Union Canal – Meadows Cycle Route

Options Appraisal Workshop

Prepared for
City of Edinburgh Council

25th July 2014

Figure 5.1 – Home Street Existing Layout

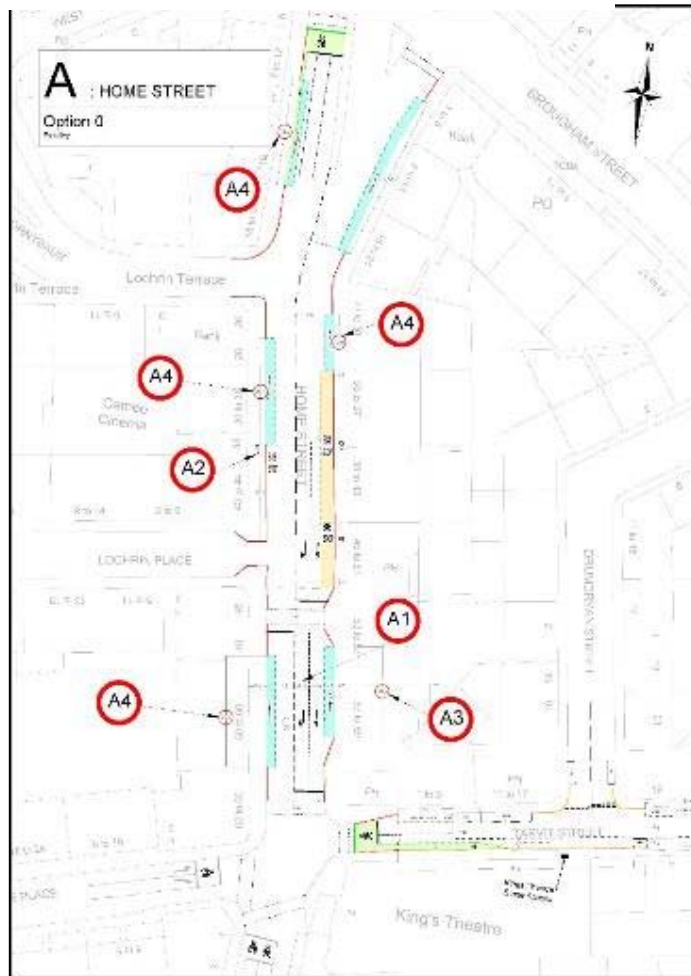
- In Option 1 the footway space is considered too narrow, particularly for disabled users.
- Introduction of Toucan crossings in all options considered a positive.
- Very desirable to include the wider footway on the east side of Home Street as in Option 3, making it the preferred option.

- West side Footway has much greater pedestrian use in rush hour and therefore needs more width than the east
- Tweak Footway and cycle path widths to address any concerns re northbound vehicle space narrowing
- 4m cycle path un-necessary – no overtaking needed here

- Reduction in footway width on west side considered to be unacceptable in Option 1
- Provision of a Toucan crossing on the cyclist desire line seen as positive across all three options, however, fundamental query raised as to whether this can be accommodated in such close proximity to the junction as it appears to be far too close at present and thus below standard
- Wider footways welcomed in Option 2 and Option 3. Agreed that street clutter needs to be addressed to ensure space is useable
- 3.0m wide segregated cycleway welcomed in Options 1 and 2, as was the 4.0m cycleway in Option 3.

- Option 3 - northbound additional bus stop may cause conflict with fire service emergency route via Lochrin Terrace if buses back up here.
- However, the additional stop in Option 3 was seen as a positive measure to potentially reduce the number of buses waiting at each stop at any one time.

- Bus stops need to be together to facilitate transfers. Possibly relocate off-peak parking and have all N-bound bus stops between Lochrin Terrace and Lochrin Place.

- Inclusion of additional stop in Option 3 seen as positive to reduce pedestrian and bus vehicle congestion.
- Bus users use the canopy at the Cameo Cinema as a shelter – moving the bus stop in Options 2 and 3 would mean that provision of alternative shelter would be required.

- All options considered slightly negative for all-day loading as in each there is a reduction in number of spaces.
- Option 2 considered slightly more preferable as reduction in spaces is less.

- Total loss of loading on south section of home Street a bit of a concern – potential compensation by using Gilmore Place for west side shops?

- Reduction in all day loading in option 3 seen as potentially unacceptable
- All day loading provided to the north of the Lochrin Place junction in Option 2 mitigates the removal of the all day loading to the south as a result of the cycleway. The group welcomed this
- Option 2 considered more preferable as reduction in spaces is less.

- Option 1 and option 3, southbound - possibility of a conflict over use of road space as buses back up from bus stops into off-peak loading bay.
- Overall Option 3 results in the biggest negative for off-peak loading (this was seen to be offset by the potential for a positive outcome for bus services, if conflict zones addressed, cycling, disabled users and pedestrians).

- Noted that off peak loading spaces often used by disabled drivers/passengers for quick access to businesses.
- Option 1 and option 3, southbound - possibility of a conflict over use of road space due to buses backing up from bus stops into off-peak loading bay.
- Option 3 results in the biggest negative for off-peak loading (this was seen to be offset by the potential for a positive outcome for bus services, if conflict zones addressed, cycling, disabled users and pedestrians).
- Reduction of spaces in option 3 seen as too great a reduction. Enforcement would be an issue for option 3 as vehicles may still park for loading purposes (illegally) and thus block the road and reduce footway width.

Figure 6.1 – Tarvit Street Existing Layout

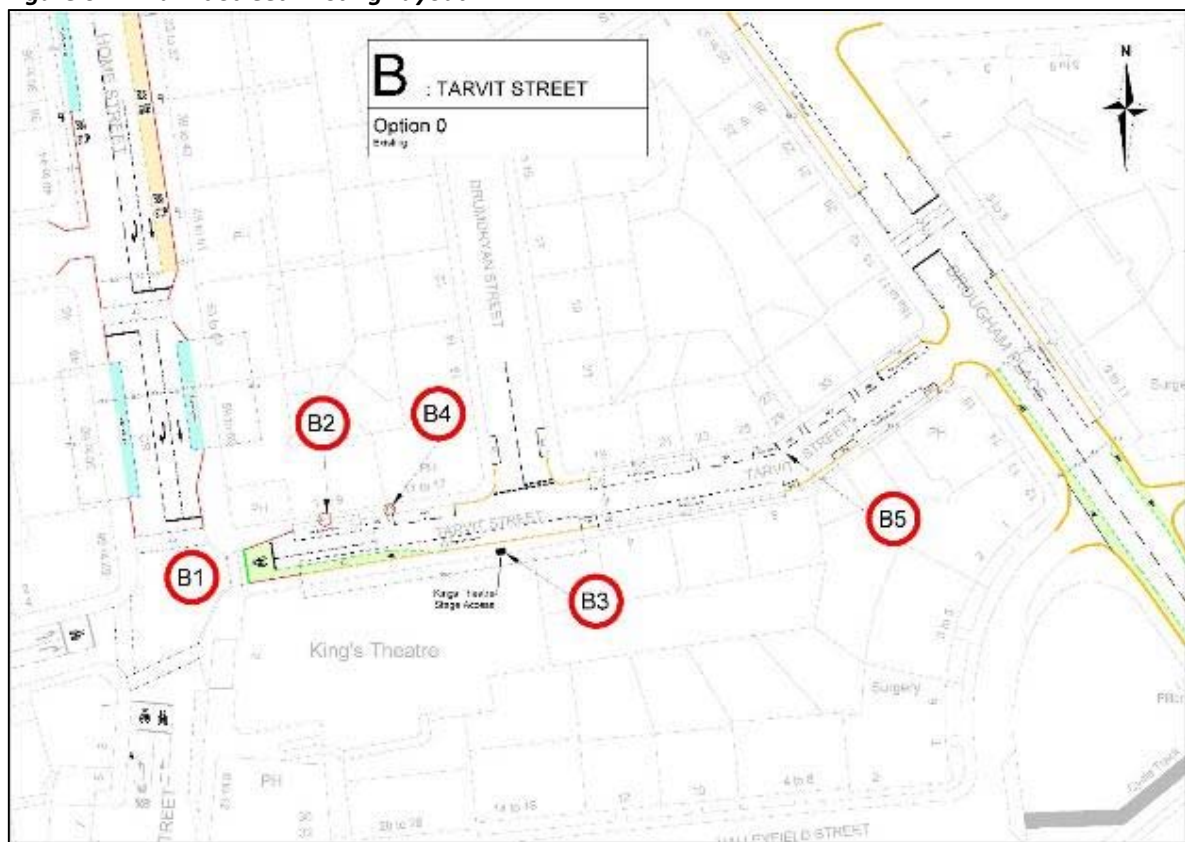
- It was agreed that all options provided a bay for Kings Theatre loading.
- A key point was the need 2 loading bays for the King's Theatre (add one to the west of the loading bay already identified in each option. This is to accommodate two articulated vehicles at the same time are required for the King's Theatre. This should be a perquisite of whichever option is taken forward. The loading bay provided on the north side of Tarvit Street in option 1 could be moved to the south of the road.

- The potential for footway widening in Option 3 was seen as the preferred option, increasing safety for pedestrians.
- Option 3 may result in some conflict between cyclists and pedestrians at the share space outside the Kings Theatre.
- Option 2 also provide benefits to pedestrians but not as significant as Option 3 due to the extent of footway widening.

- A question of whether the cycleway (eastbound) and parking could be swapped round in option 1 was raised.
- Whilst option 3 was ranked as preferred option by the majority there was at least one vote for option 2. A mix of Option 2 and 3 was suggested.

Figure 7.1 – Home Street Existing Layout

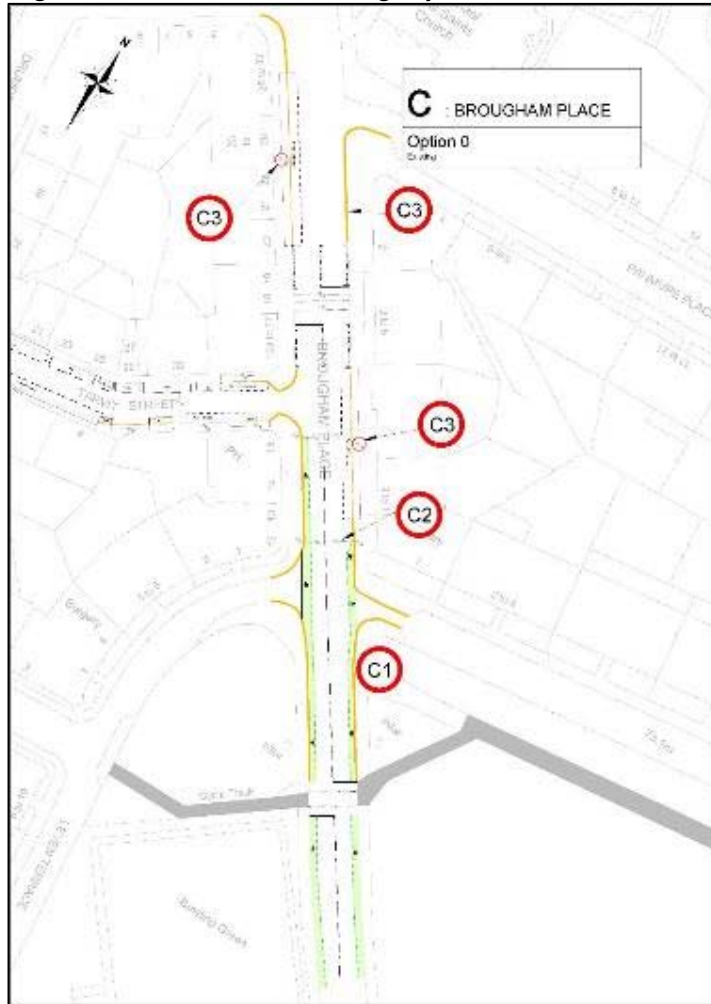
- Option 2 and 3 provide more overall parking but this was not considered a huge advantage for this area considering the level of demand. However it was noted that loss of parking on Tarvit Street may be accommodated on Brougham Place should space permit.

The Blue Group spent longer discussing Section C Tarvit Street than the other groups and therefore had limited time to consider all three Brougham Place options in detail. However it was felt by all those present in the group that Option 1 was preferable since options 2 and 3 provided minimal additional benefits for cyclists over the existing situation. Furthermore it was felt that Option 1 would assist in providing a consistency of design throughout the route under consideration.
